R. L. HAYES 2ND ADDITION

Re: S/D 98-44 -- One-Step Final Plat of R. L. HAYES 2ND ADDITION

CASE NUMBER: S/D 98-44 - R.L. HAYES 2ND ADDITION

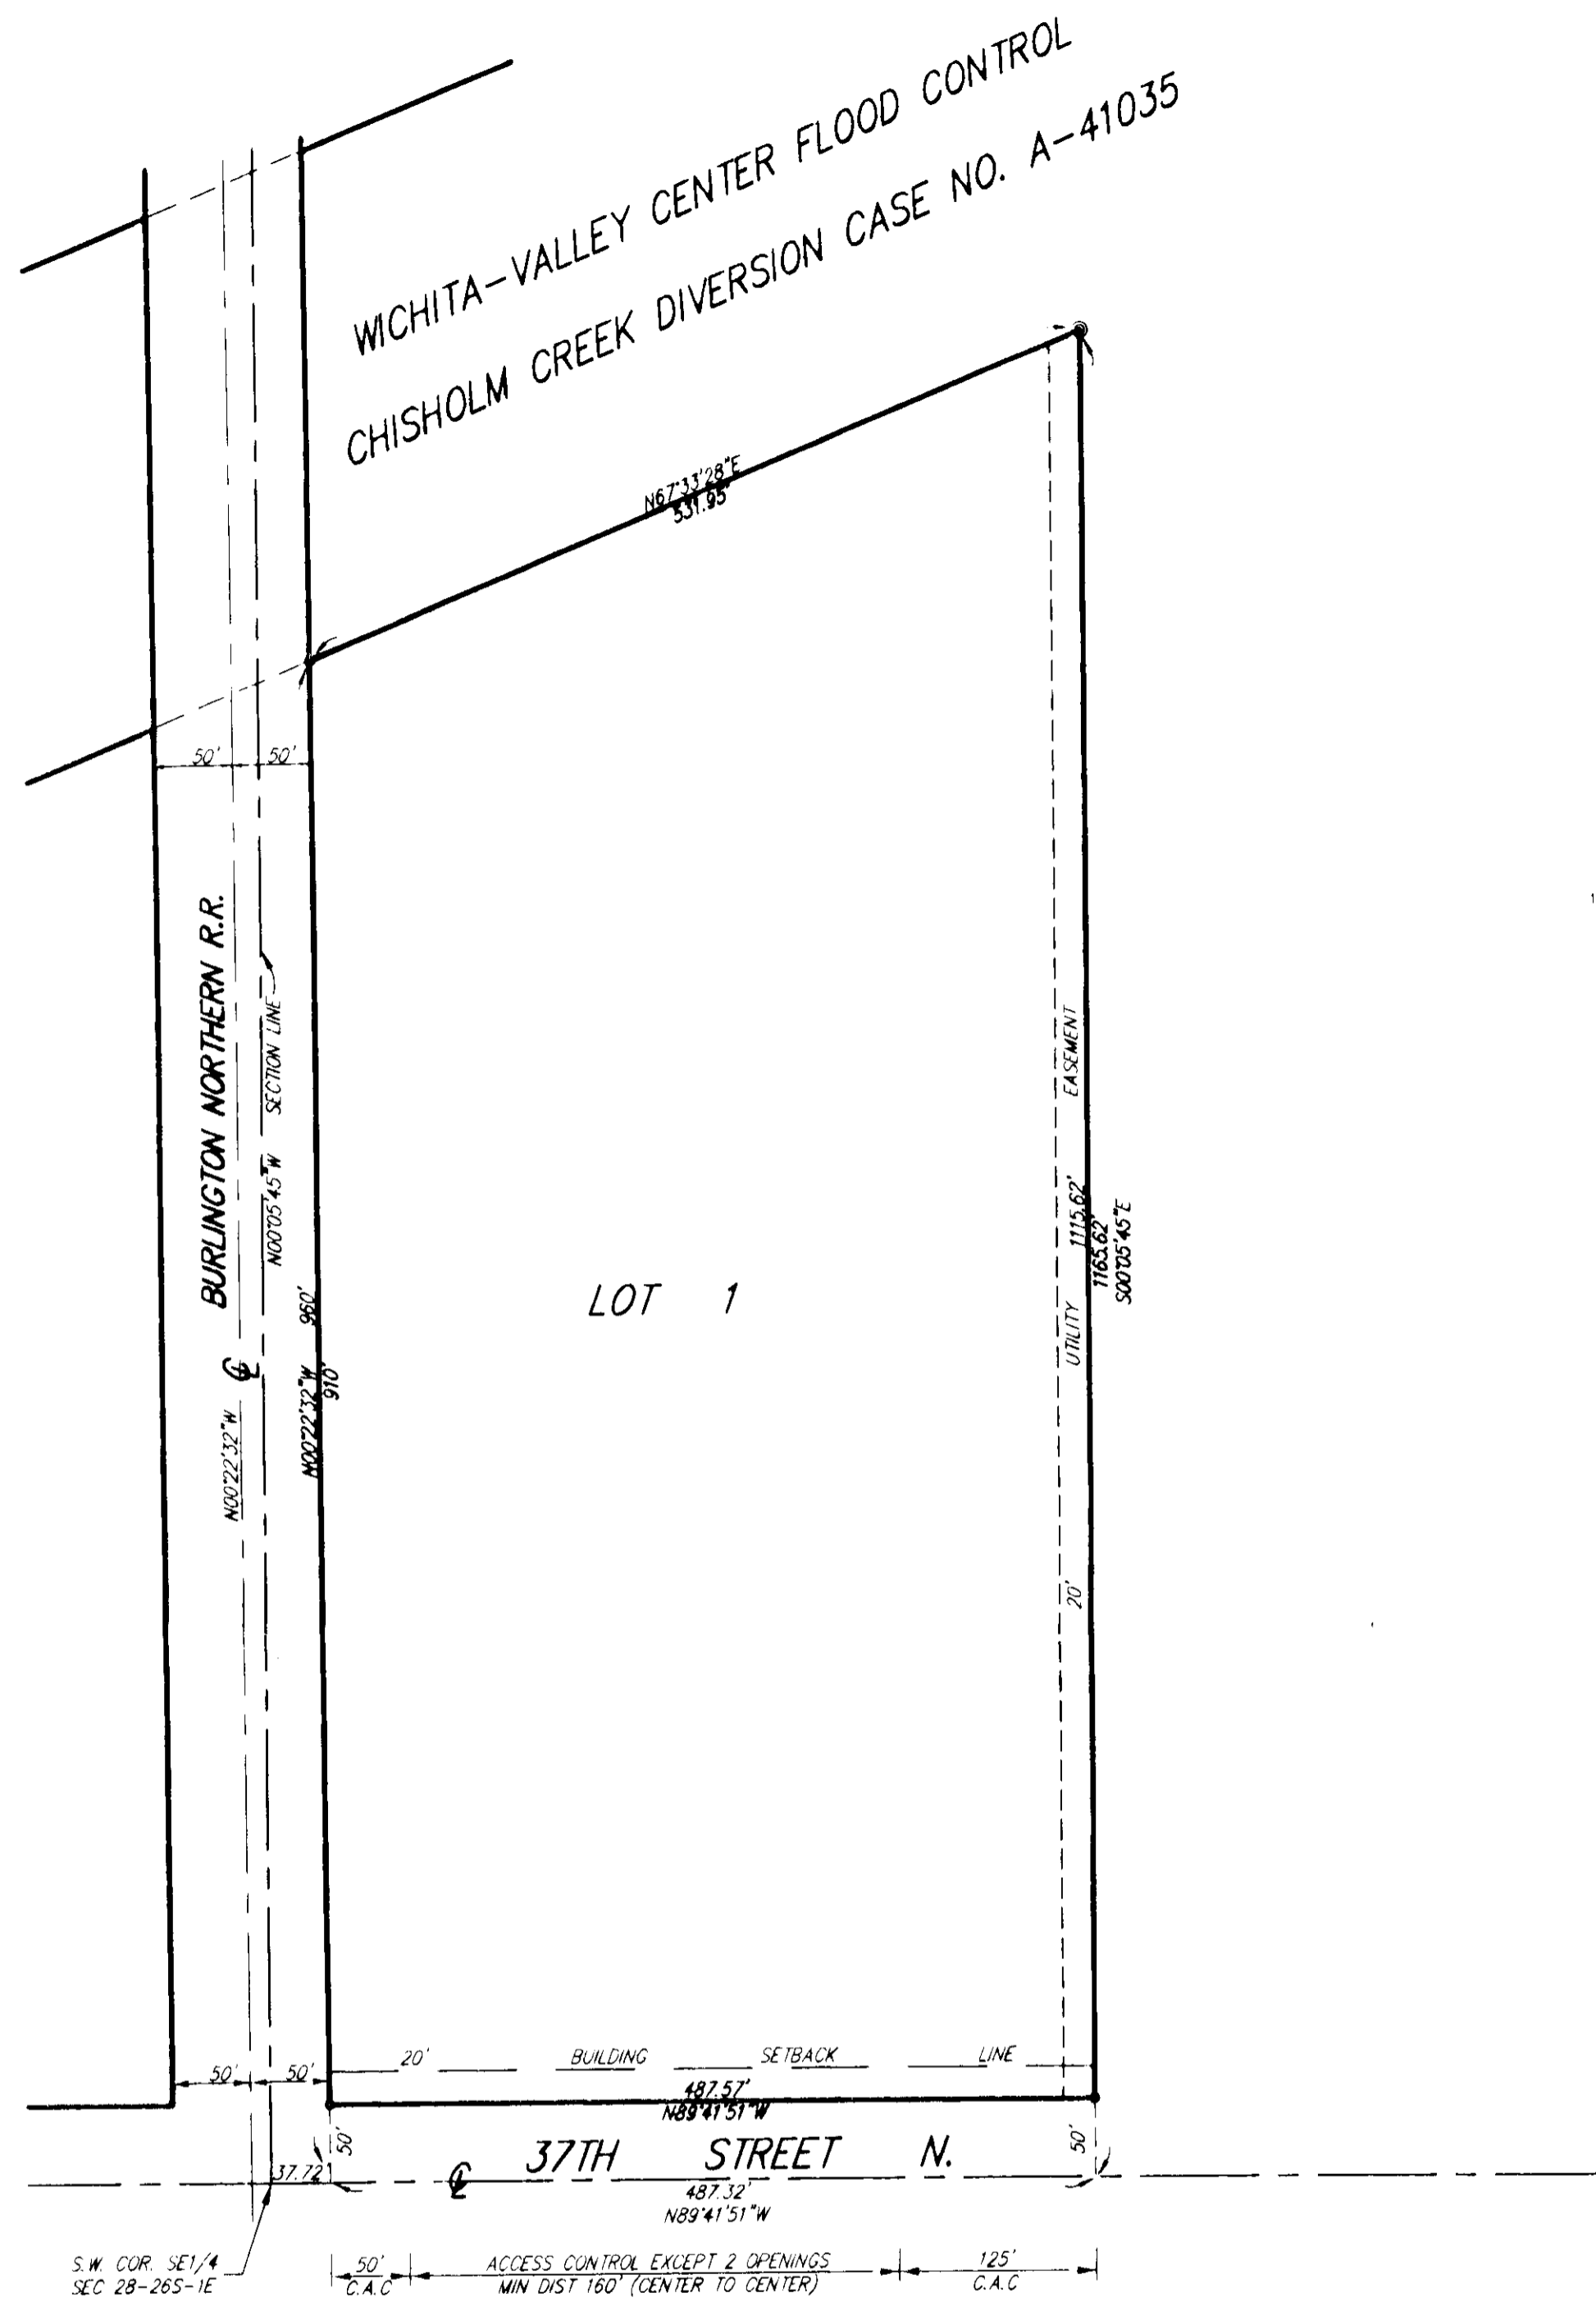
- E. Traffic Engineering needs to comment on the acceptability of access controls. The plat denotes three access openings along 37th Street North. Traffic Engineering has approved two openings with a minimum of 160 feet (center to center) between the openings. 50 feet of complete access control is requested adjoining the west line of the plat. 125 feet of complete access control is requested adjoining the east line of the plat.

- G. The legal description needs to be revised to accurately portray the land being platted. The distances on the drawing need to be identical to those on the legal description.

- H. The applicant is advised that the required building setback is 20 feet; however a 35-foot setback will apply to this site if platted as shown.
- I. The MAPC Chairman signature block needs to be revised to read, "Richard E. Lopez".

- J. The Register of Deeds signature block needs to be revised to read, "Bill Meek".
- K. Traffic Engineering needs to comment on the need for any improvements to 37th Street North.
